ADDENDUM 02

DATE 02.10.23
 PROJECT NO. 2154
 PROJECT WEST FIELD SR. SEMINARY
 FROM STUDIO 333 ARCHITECTS

This Addendum consists of 2 pages and the attached Drawing Sheets CE1.1 SITE PLAN, CE3.1 UTILITY PLAN, A1.11 1ST LEVEL REFLECTED CEILING PLAN, A1.31 FINISH SCHEDULE & LEGEND, EE603 SCHEDULES and EL101 1ST LEVEL LIGHTING PLAN, SO.02 STRUCTURAL NOTES.

A1.11

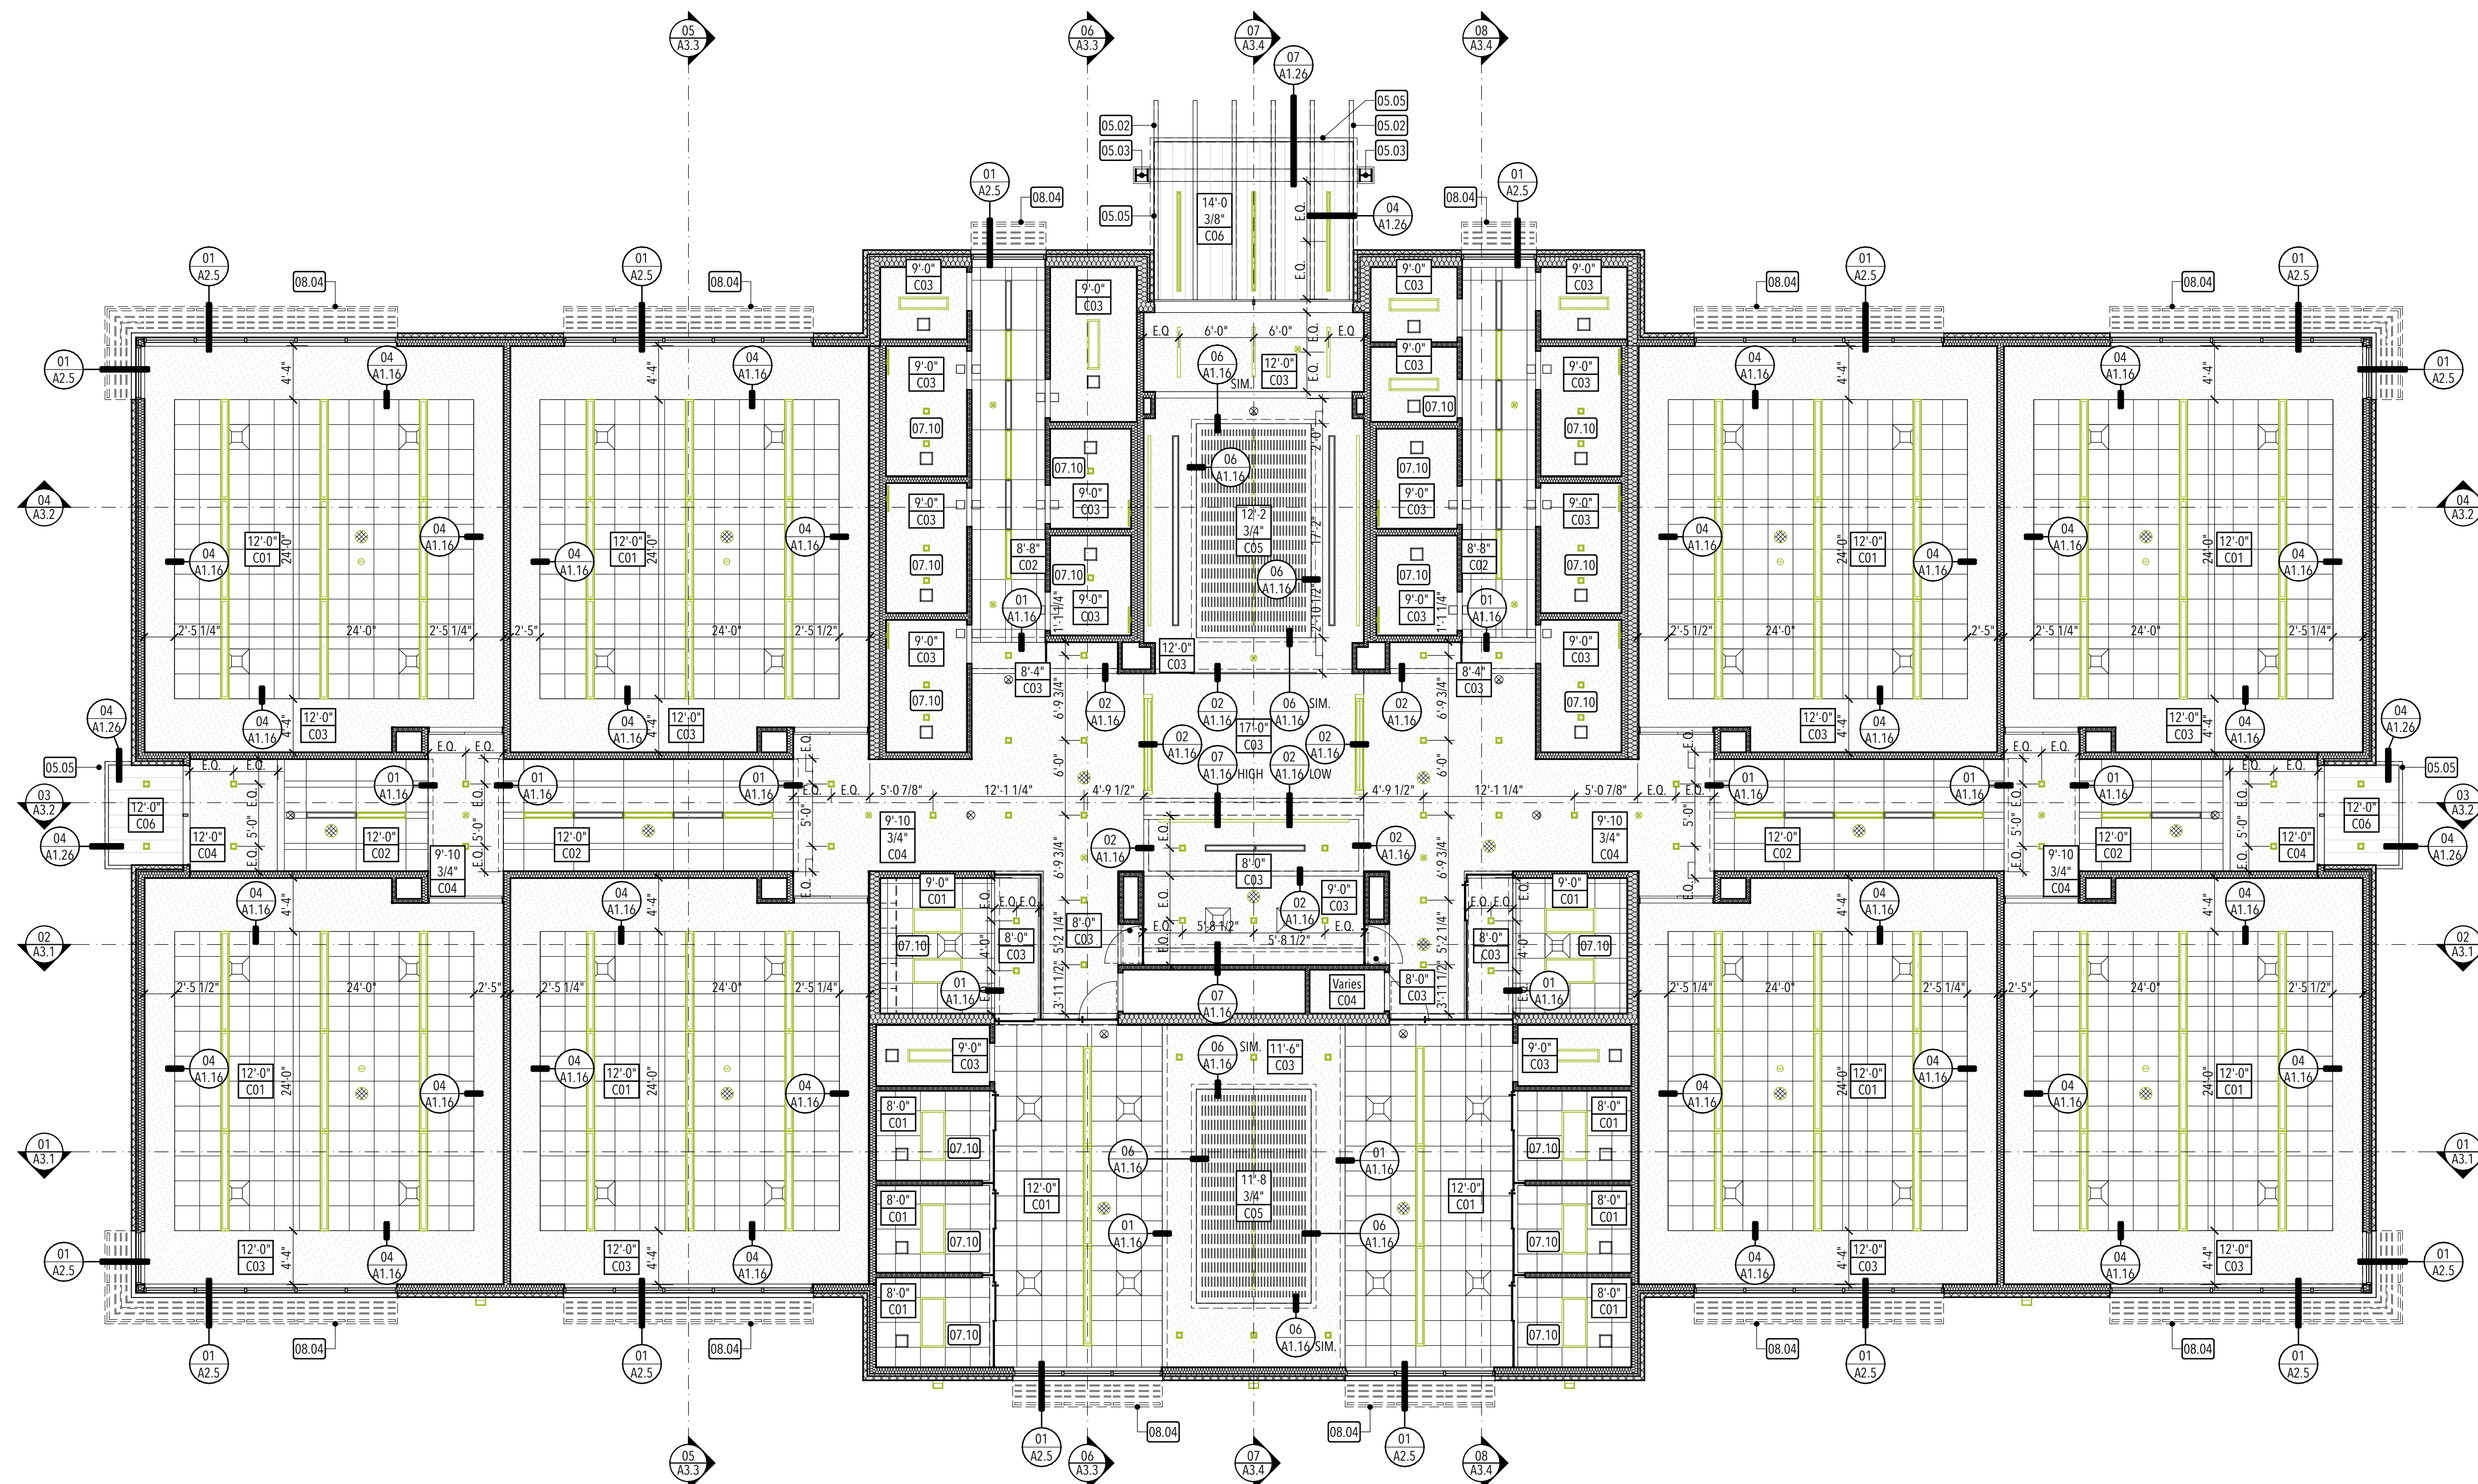
- a. General Ceiling Note "L" should refer to type "C03" instead of "C06".

S0.02

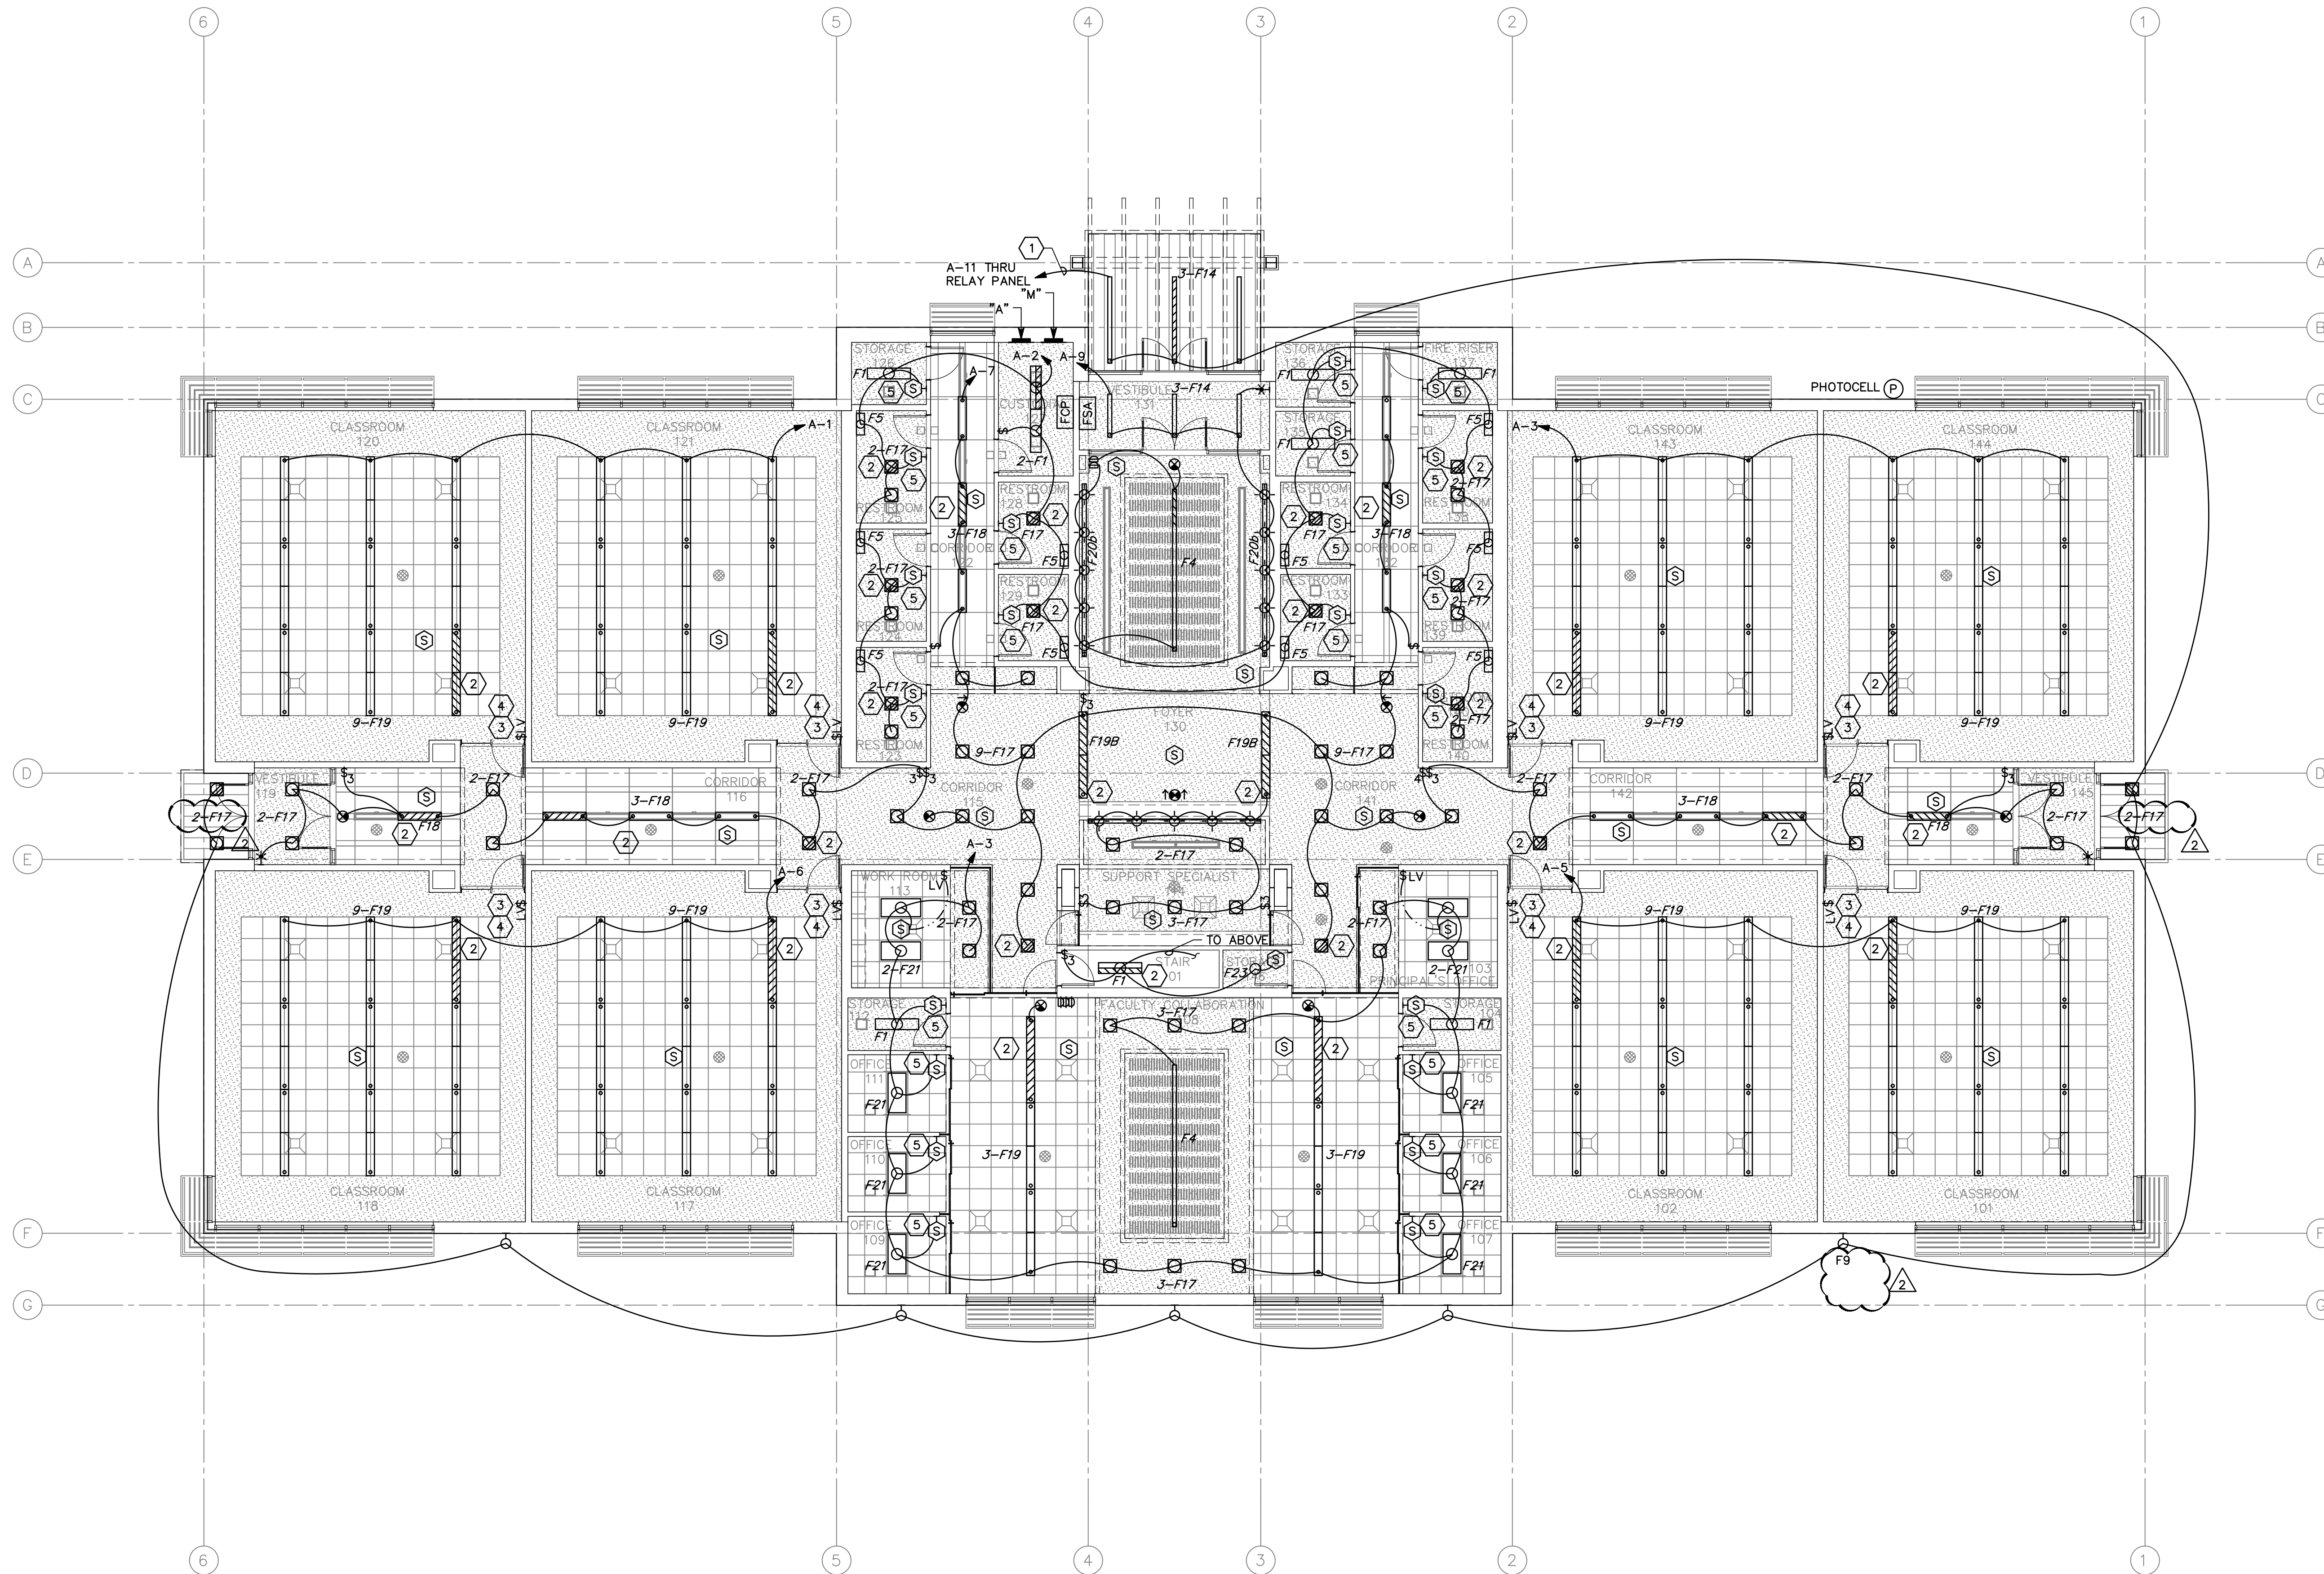
- a. Change callout for (2) exterior lights at west and east ends from (2) F14 to (2) F17.
 7. Sheet S0.02 STRUCTURAL NOTES:
 - a. Note 0.1.a.2: Update note to indicate to use 2.0E LVL for posts, timbers, and vertical studs.
